Building Code of Australia 2022 Report – Vol1

Report for BCA Compliance – Rev E

PROJECT NAME: Tumbi Umbi Retirement Living Project – 14 Mingara Drive, Tumbi Umbi, 2261.
PROJECT NUMBER: **GDL230520**
DATE: **27/07/2024**

Figure 8 - Fire Source Feature

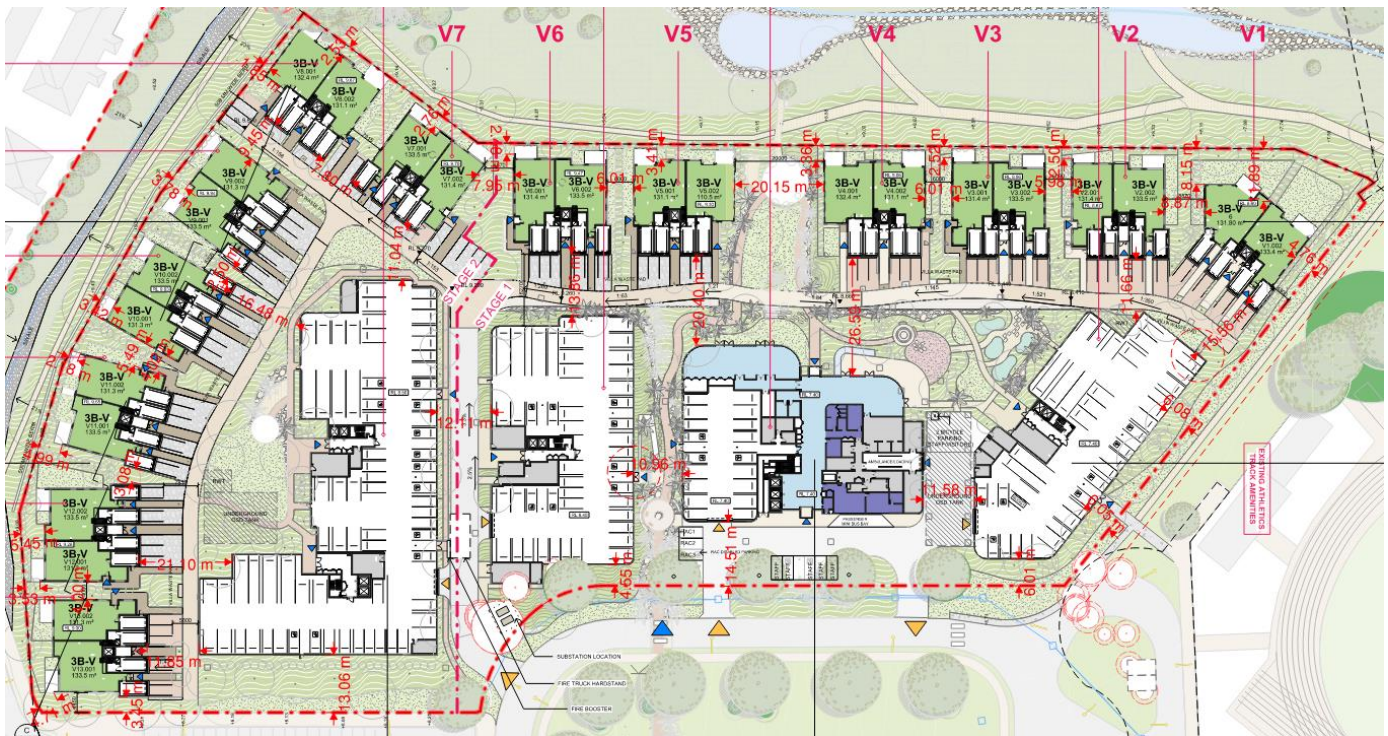
*Architect to provide set plan for each villa and the associated location of the closet fire source feature for further assessment

Figure 9 - Flood Map From ePlanning Spatial Viewer

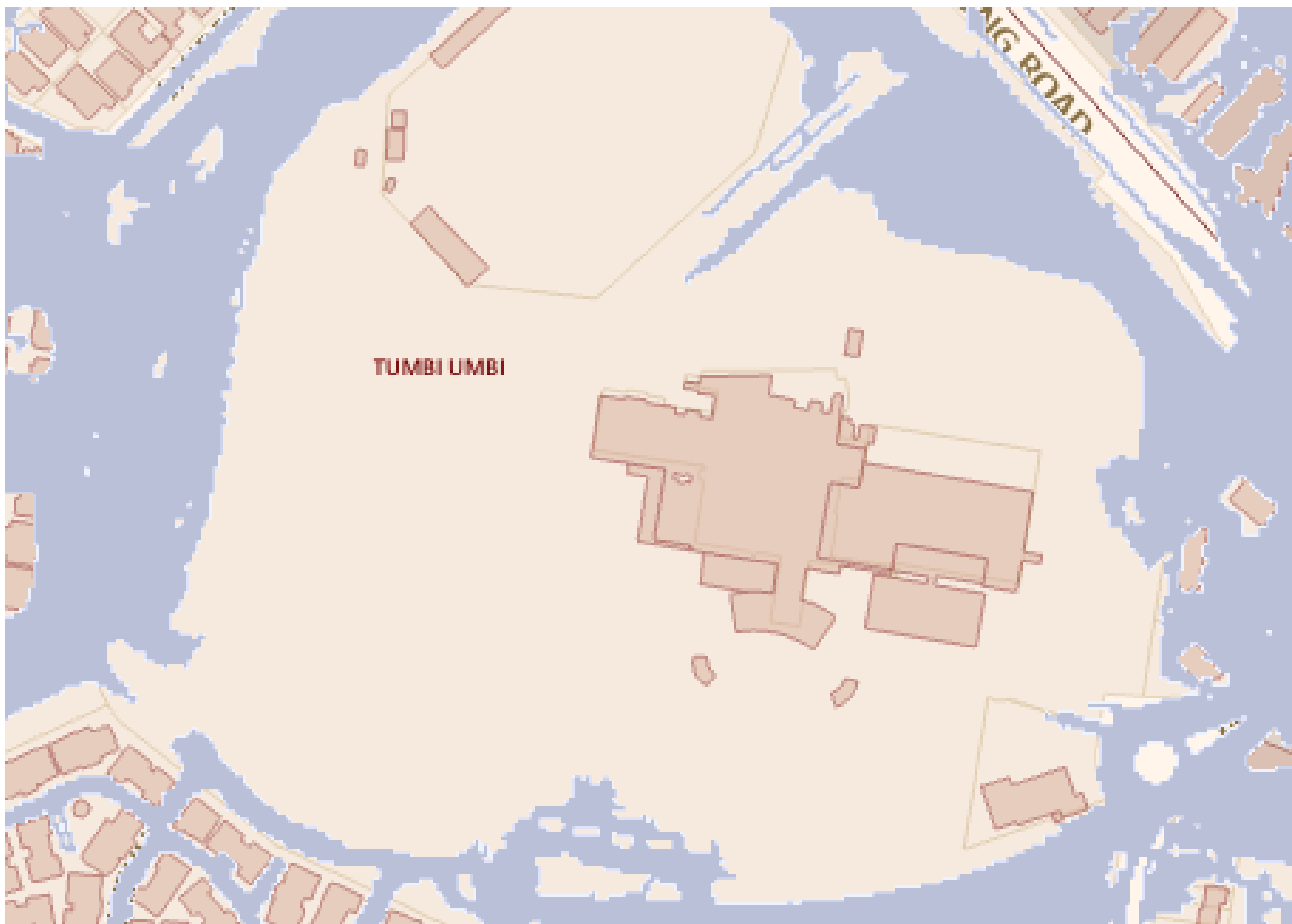
Comment: The building is proposed to be constructed on flood prone land, refer Figure 9 below, extracted from the Central Coast Council Online Mapping Tool, however, is subject to an assessment from the Development Consent Authority.

Figure 10 – Age Care Smoke Compartments

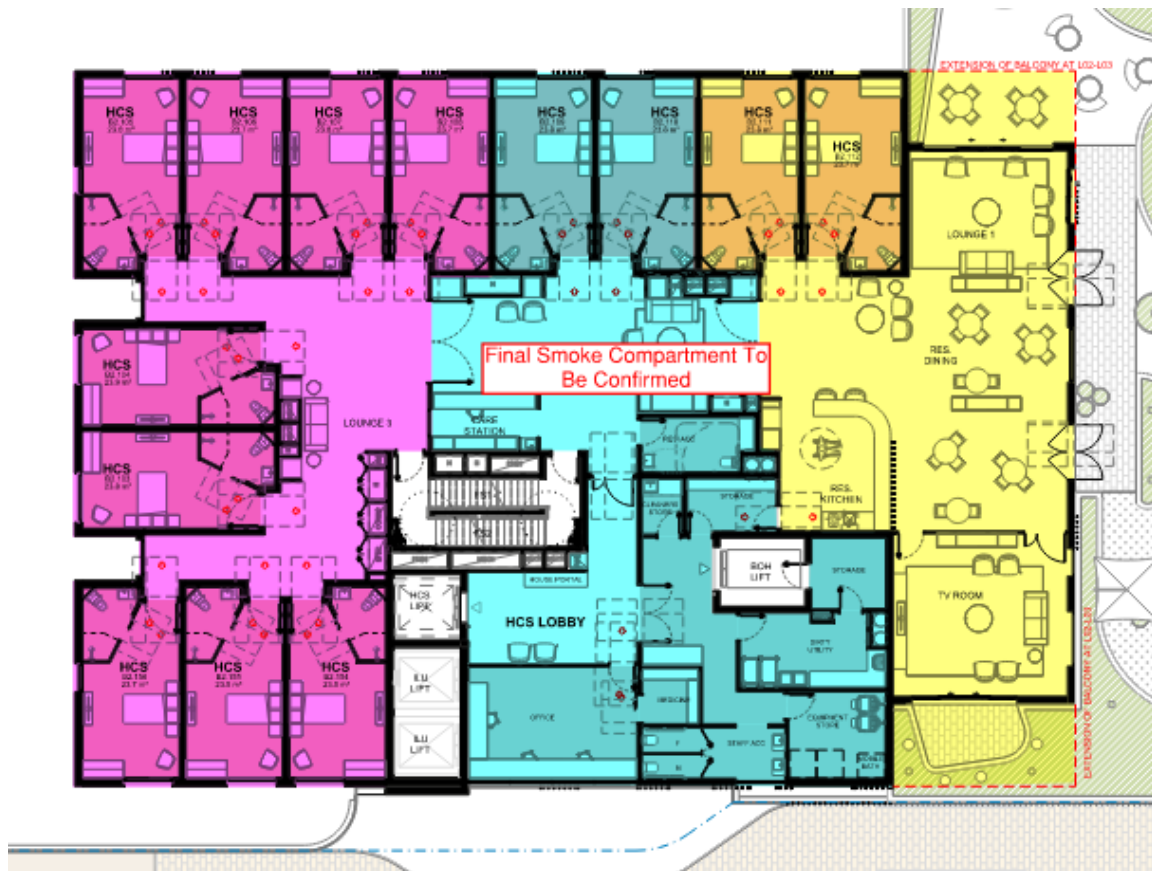
Note: The Age Care building has been designed to be divided into areas not more than 500m² by smoke proof walls complying with Specification 11. Refer Figure 10 below. Final compartment lines are to be confirmed by the Architect.

Figure 11 - Building 4 Corridor Length

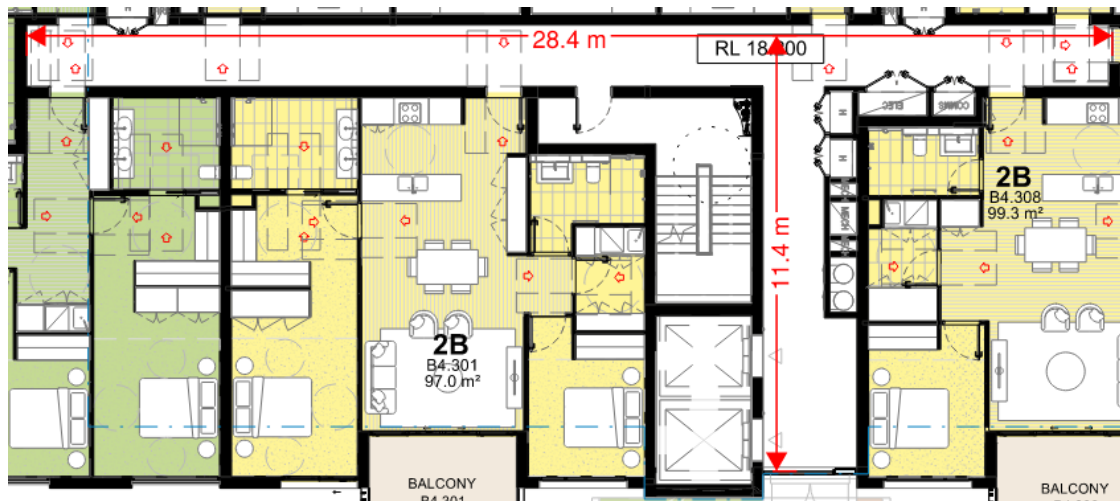
Comment: Compliance appears to have been readily achieved. Note the corridor length of the typical floors of Building 4 are currently designed to 3982m. The Architect is to ensure this corridor does not exceed 40m in length, or if so, includes the provision for smoke-proof walls.

Figure 13 – Non-compliant fire rated egress door.

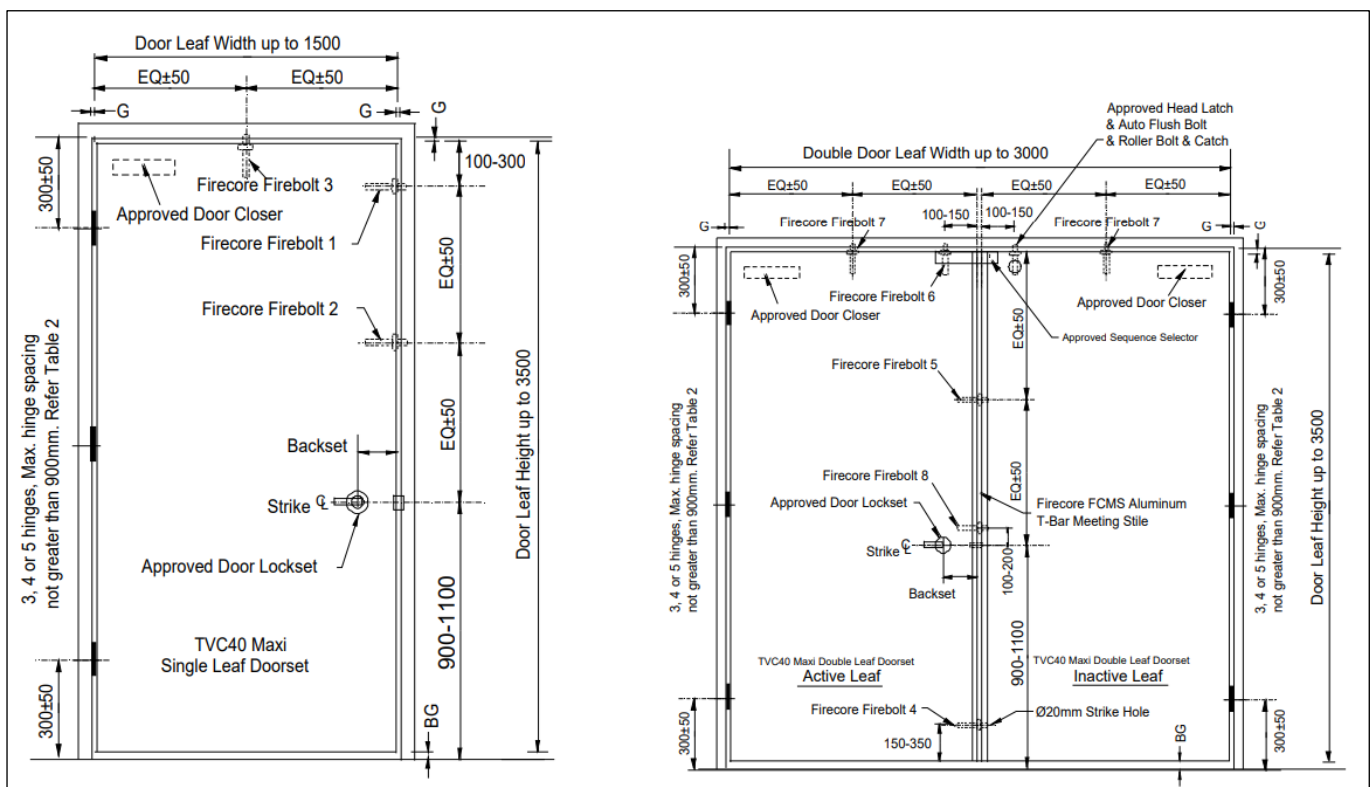
It is understood that several current fire door and jamb test reports conducted under the latest BCA standard (AS 1530.4-2015 and some older ones to AS 1530.4-2004) may contain the use of pop-up fire bolts or the like which uphold the integrity of the fire door. Such pop-ups or the like are not permitted to be used on doors that are 'required' exits doors or doors that are required path of travel doors which are to maintain egress operation in the event of a fire. Figure 13 below illustrates a compliant egress fire door because it contains fire bolt.

The design team will need to provide the specific fire test reports for each fire door for review and comment. We suggest that this is actioned as soon as possible in case the FER is required to be updated.

Figure 14 - Villa Level 1 Lobby

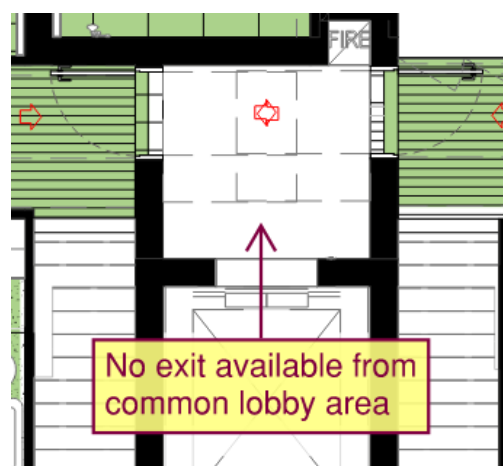
The Fire Safety Engineer has confirmed the feasibility of a justifiable Performance Solution for inclusion within the Fire Engineering Report, in principle, subject to review of the Fire Engineering Report.

Figure 15 - Inadequate distance between required exits and convergence of alternative exit paths

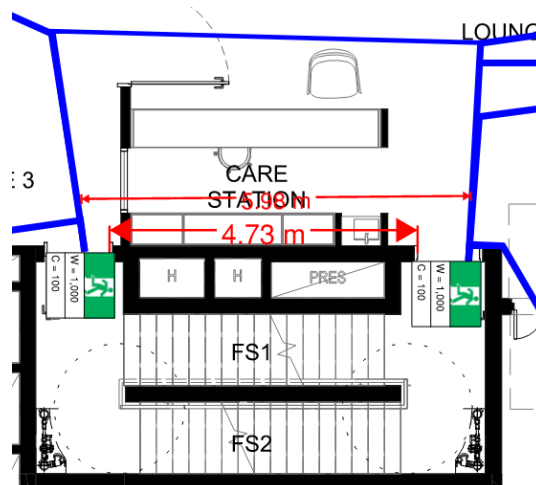
- (a) Building 2 – RAC (Level 1-3) The two required exits which are used as an alternative means of egress, are located less than 9 m apart, actual 4.73m. Refer Figure 15 below.
- (b) Building 2 RAC (Level 1-3) – The alternative exit paths converge that they become less than 6m, actual 5.98m.

The Fire Safety Engineer has confirmed the feasibility of a justifiable Performance Solution for inclusion within the Fire Engineering Report, in principle, subject to review of the Fire Engineering Report.

Figure 16 - Doorways in External Wall Protection

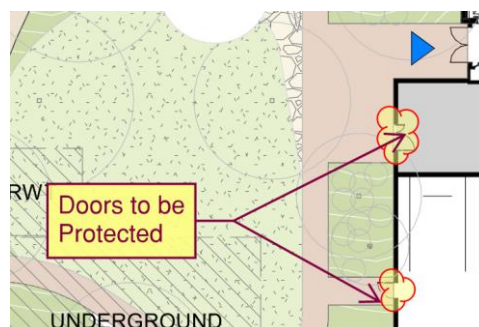
Architect to ensure all door openings along the external wall where the path of travel from the fire-isolated stair discharge passes within 6m, are protected.

Figure 17 - Stairs discharging not as far as part from each other.

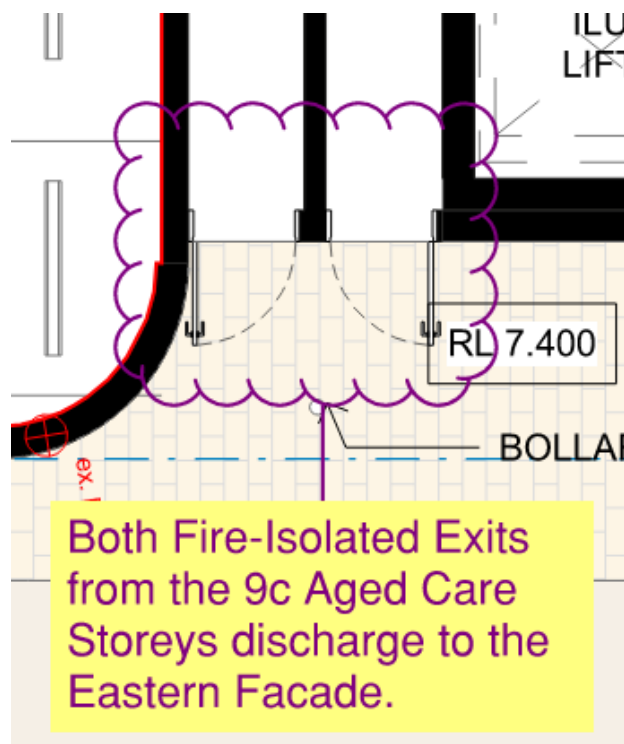
- (a) **All Buildings** - The egress paths from each building adjoins to another allotment boundary instead of a road and therefore the exits paths from each building do not have compliant path to the road. The Fire Safety Engineer has confirmed the feasibility of a justifiable Performance Solution for inclusion within the Fire Engineering Report, in principle, subject to review of the Fire Engineering Report.
- (b) **Building 2** - The discharge point of alternative exits must be far apart as practical so that if one exit is blocked, the other will still operate satisfactorily. Both Fire Isolated Exits from the 9c Age Care Storeys discharge to the East Façade. The Fire Safety Engineer has confirmed the feasibility of a justifiable Performance Solution for inclusion within the Fire Engineering Report, in principle, subject to review of the Fire Engineering Report.

Figure 19 - Sliding Doors Auto Open

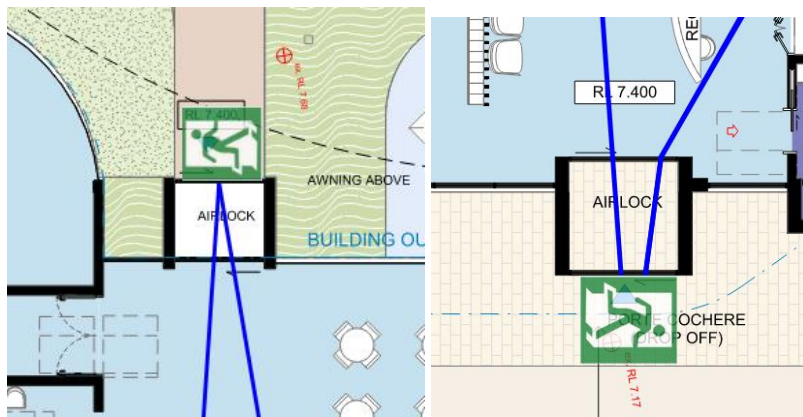
The Fire Safety Engineer has confirmed the feasibility of a justifiable Performance Solution for inclusion within the Fire Engineering Report

Figure 21 - Internal FHR

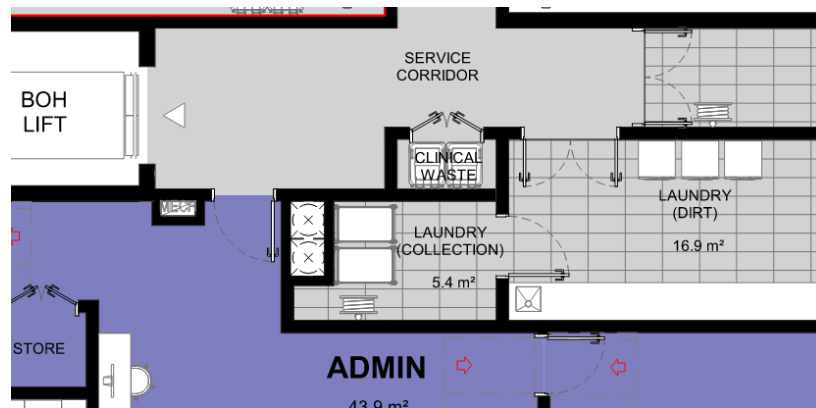
Note: a number of internal rooms have been provided FHR which may not require them, example below. These locations appear to not have compliant clearances. Further coordination required with Service Engineer where these FHR is not required should be removed
